**AGENDA  
CITY OF ST. CHARLES  
PLANNING & DEVELOPMENT COMMITTEE  
ALD. CLIFF CARRIGNAN – CHAIRMAN**

Title:	Recommendation to approve a Map Amendment, Preliminary Subdivision Plan and Final Plat of Subdivision (Delnor Woods Subdivision)
--------	--

**RE:** Delnor Woods Subdivision

The following are outstanding comments on the plan submittal of January 15, 2013, in addition to review comments from Development Engineering:

### TREE PRESERVATION PLAN

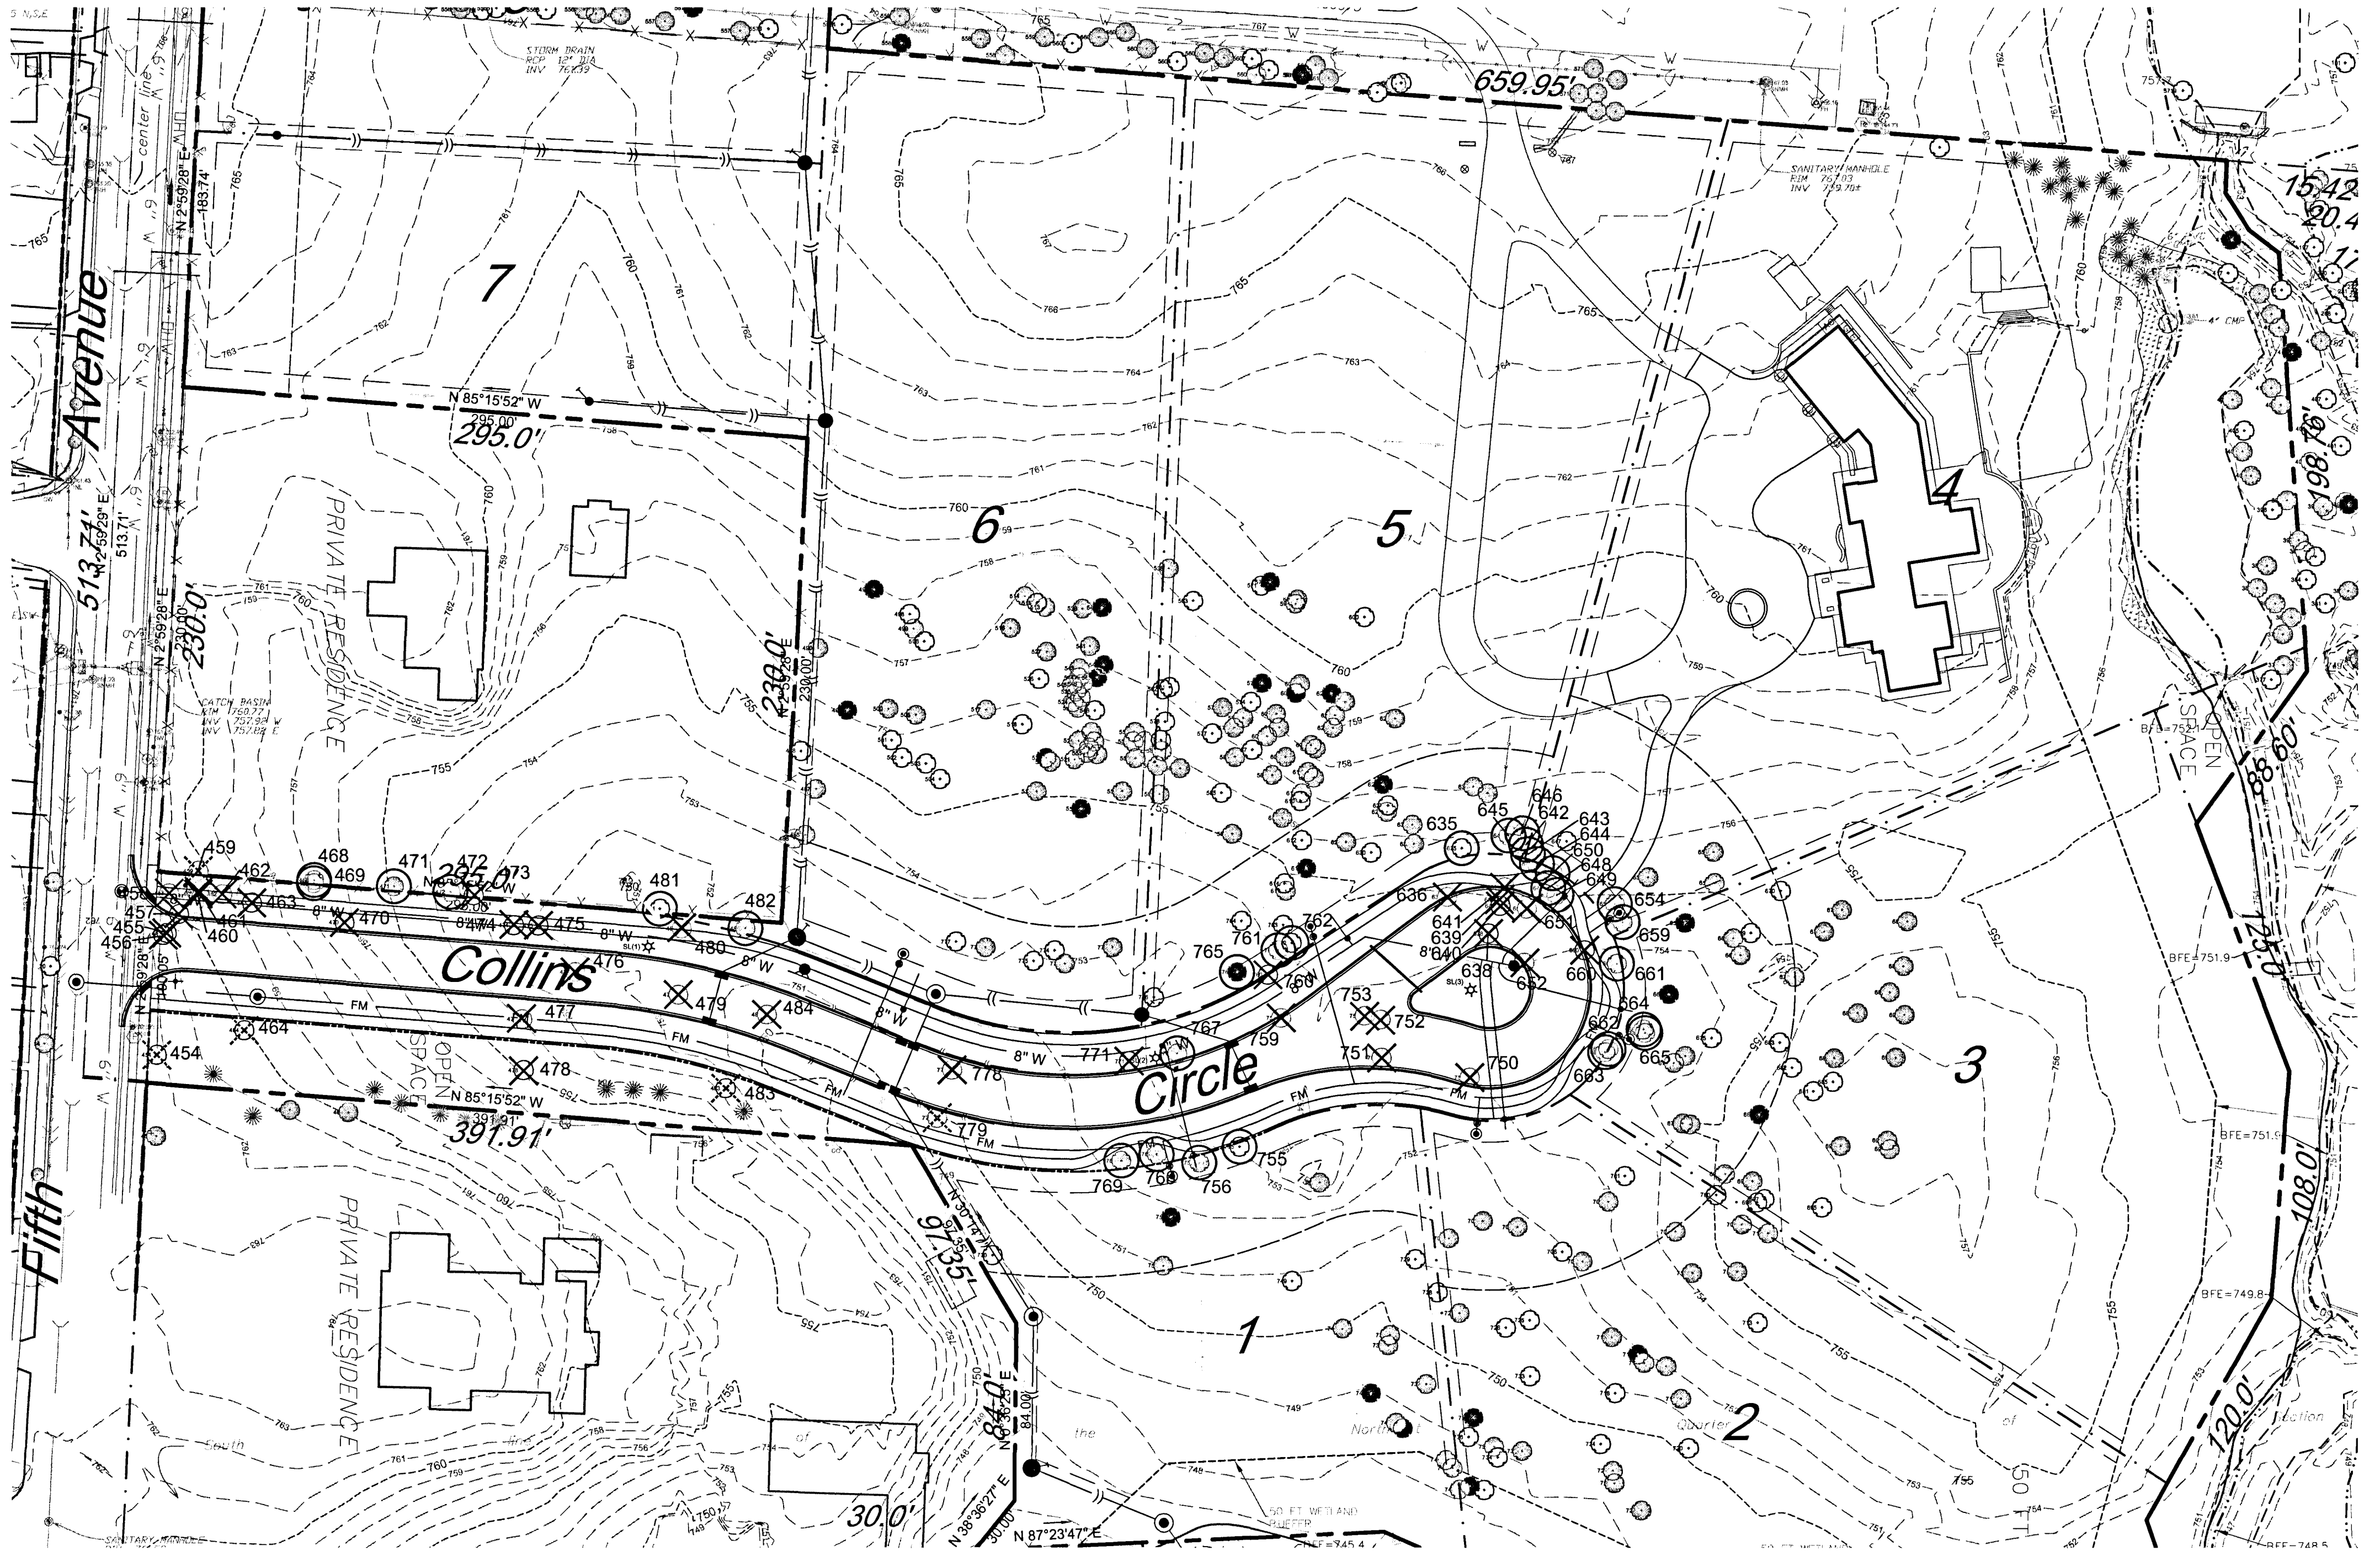
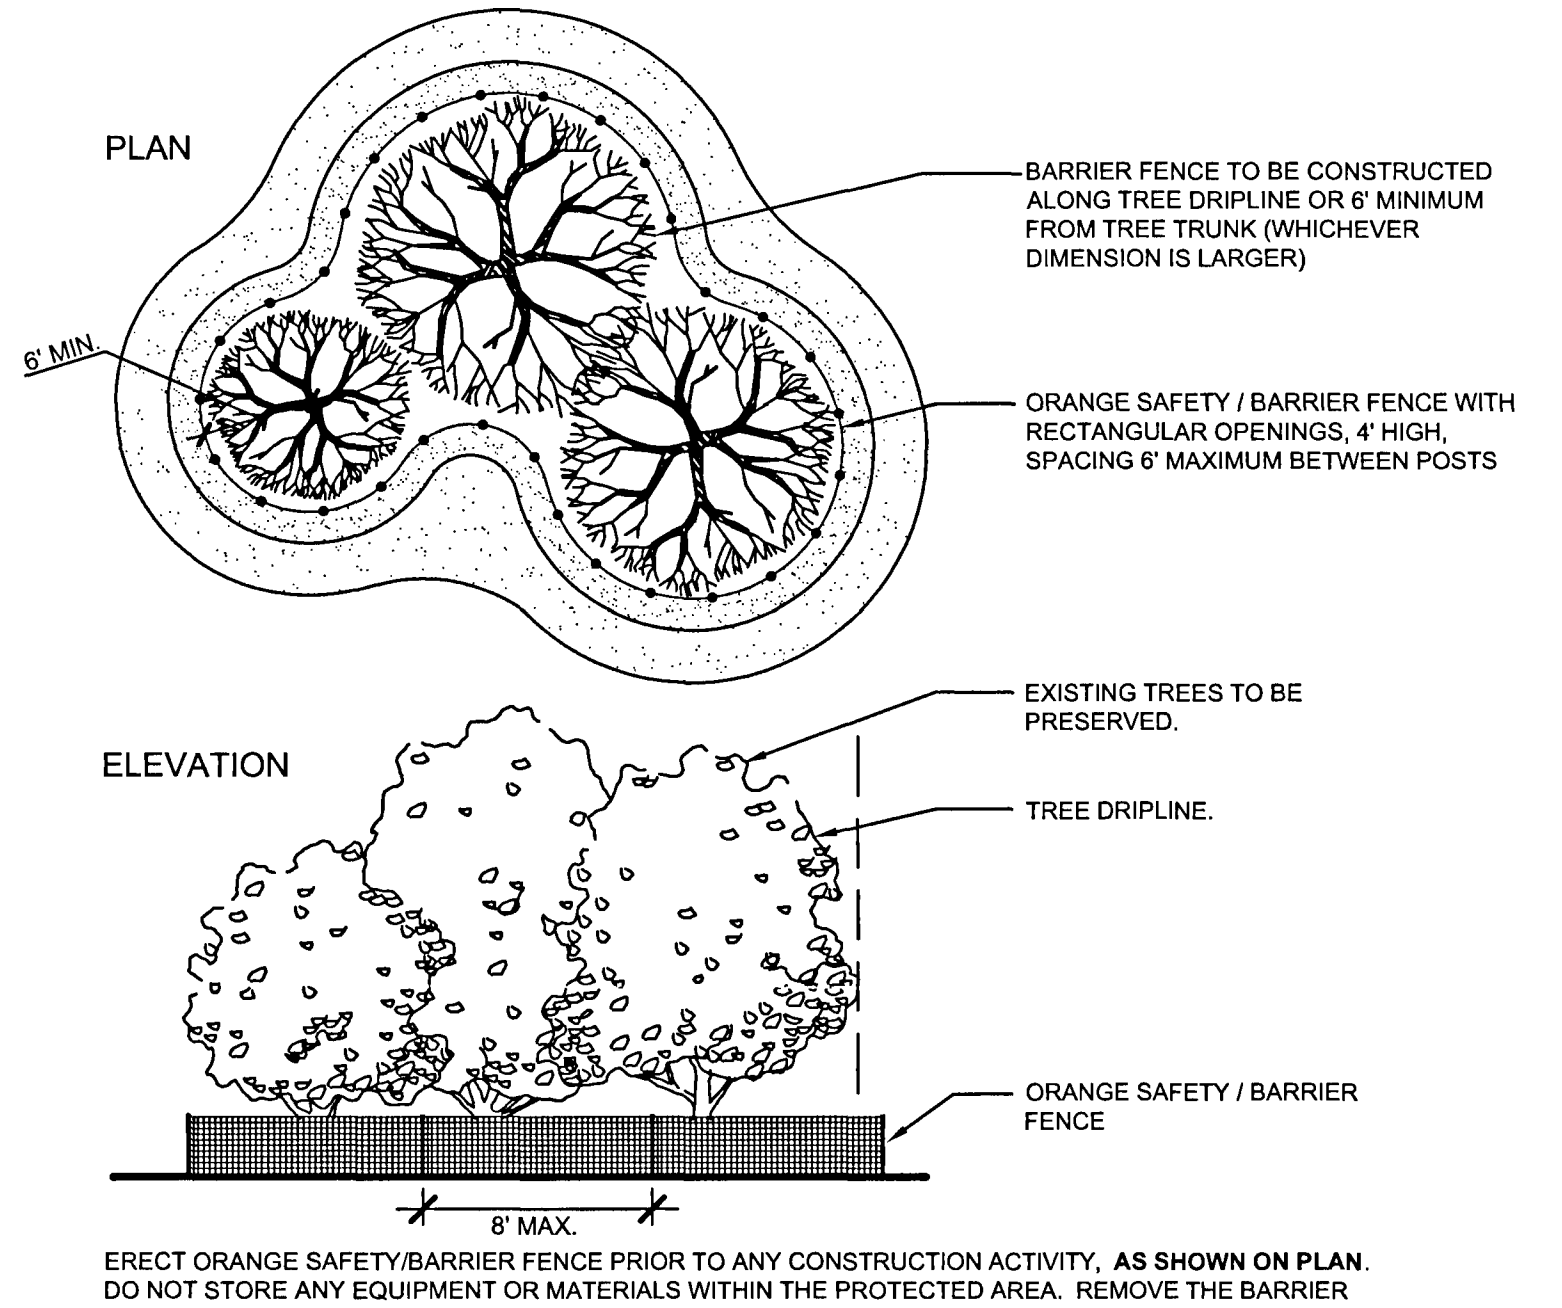
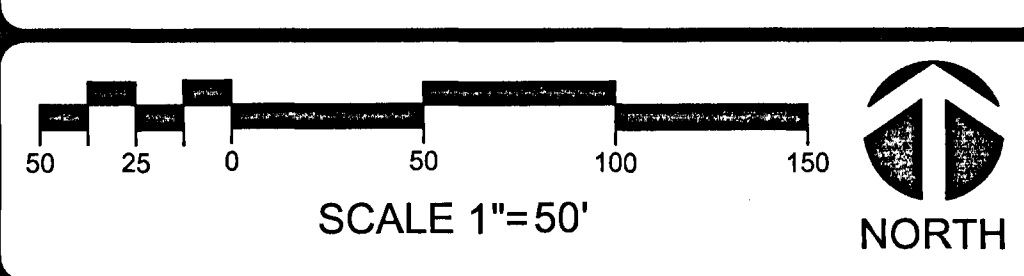
1. City Code Chapter 8.30 requires review and approval of a Tree Preservation Plan identifying all trees over 6" in DBH before issuance of a site development permit or building permit in new subdivisions. The plans submitted address the area surrounding Collins Circle but do not show other locations on the property where infrastructure will be installed or grading will occur. Information on these areas is needed before site work commences. Information on tree removal related to construction of buildings can be provided at the time of building permit.

31. The tree protection plan will not be able to be completed with the installation of new utilities in the parkways. Examples are the water service to lot 1 and lot 4
32. On sheet #8 Demotion Plan,
33. A) The abandonment procedure for the valve vault in Rt. 25 shall be a flange cap installed on the pressure tap sleeve. A note should be added that the vault at this location should also be abandoned.
